General
Sheet Index, Legend & General Notes

Pacific Fibre Products
Fire Line Extension
Molalla, Oregon

Drawing Number:
G2

Notes and Details

TYPICAL TRENCH DETAIL

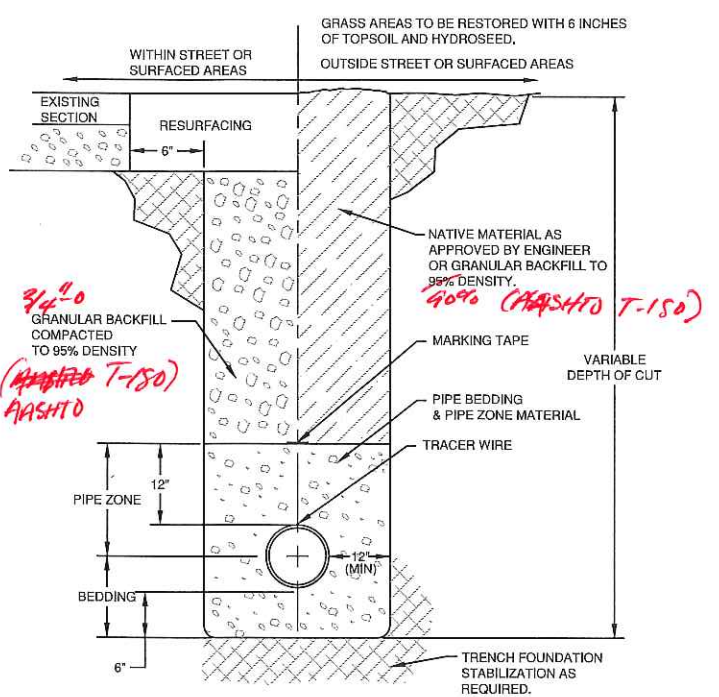
SEE NOTES FOR ROADWAY SECTION IN PUBLIC R/W ONLY

** SEE PROVIDED STANDARDS*
